P-0616-005
July 27, 2022

Re: **Amendment to Minor Impact Permit Application**
File Number 2022-01782
Portsmouth Regional Hospital Satellite Parking Lot
Borthwick Avenue
Portsmouth, New Hampshire

Project Updates

OVERALL PARKING PLAN

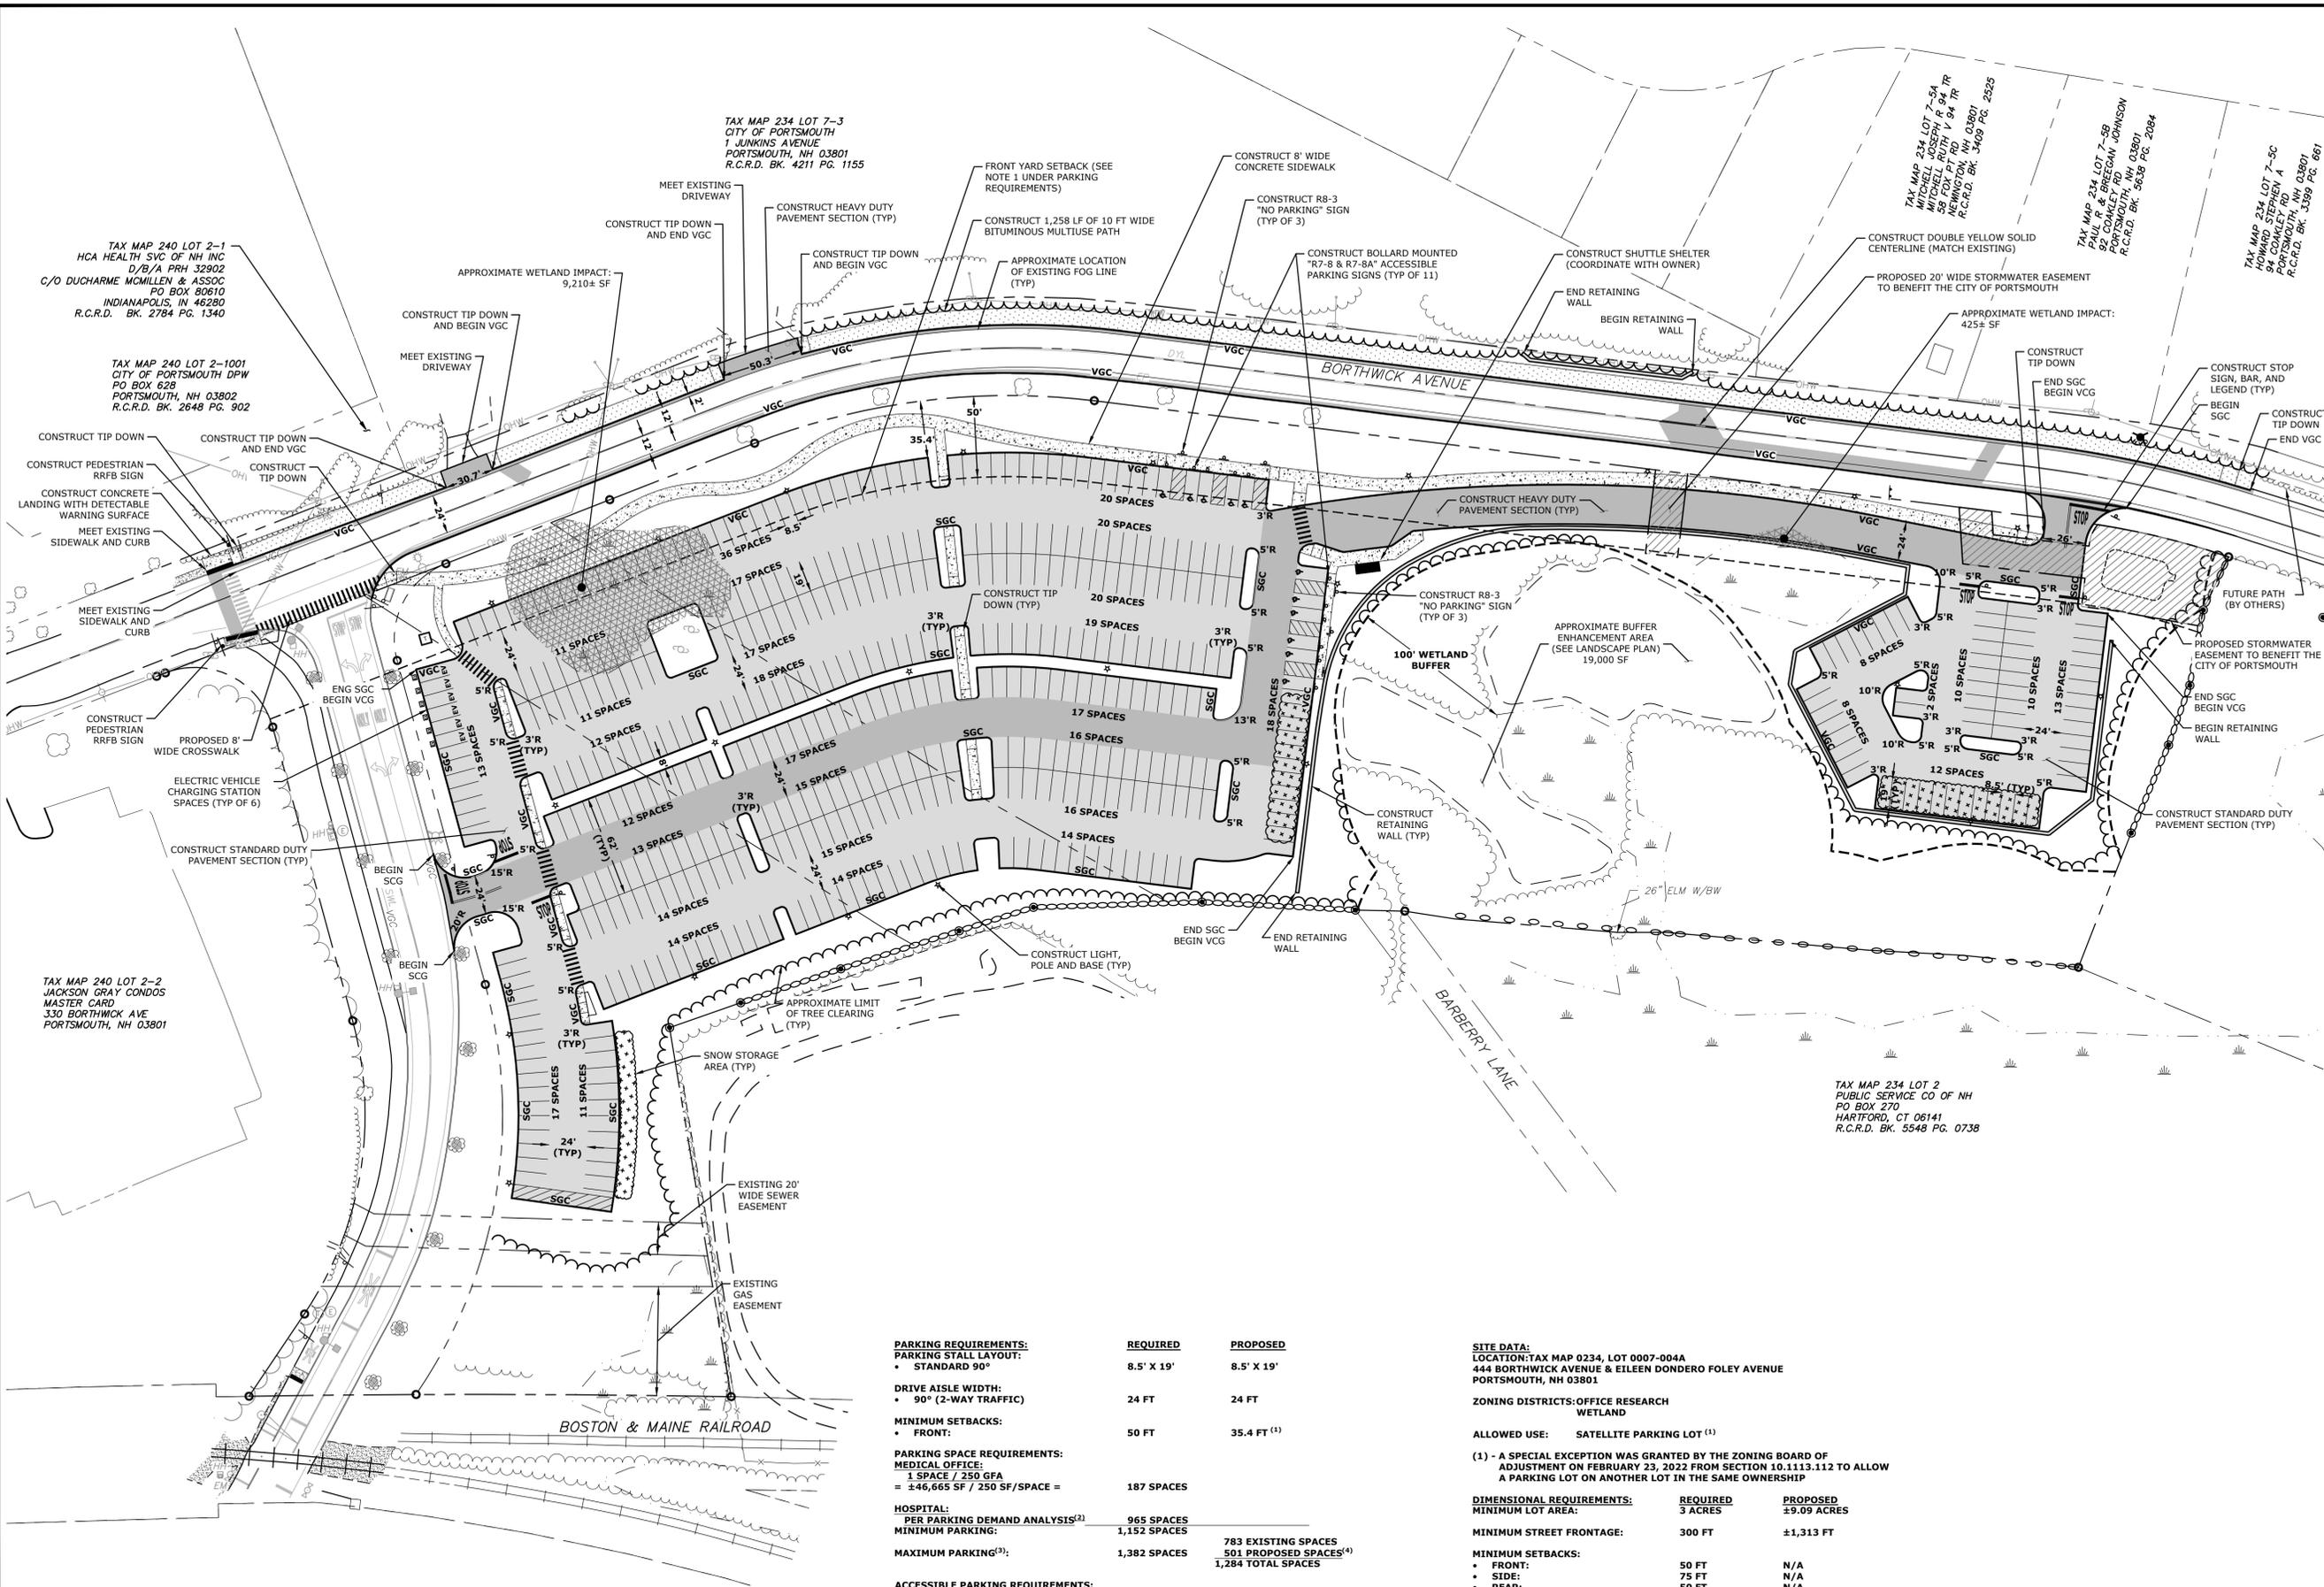
- The vehicular access aisle connecting the two parking lots shifted closer to the property line to lessen the permanent impacts to the existing wetland, identified as Wetland 2.
- The two proposed retaining walls along the northwest corner of the parcel have been removed, resulting in increased permanent impact to Wetland 5.
- Other changes include the completed design development of the multiuse path along Borthwick Avenue and drainage updates associated with the technical review comments previously referenced which result in no significance to this application.
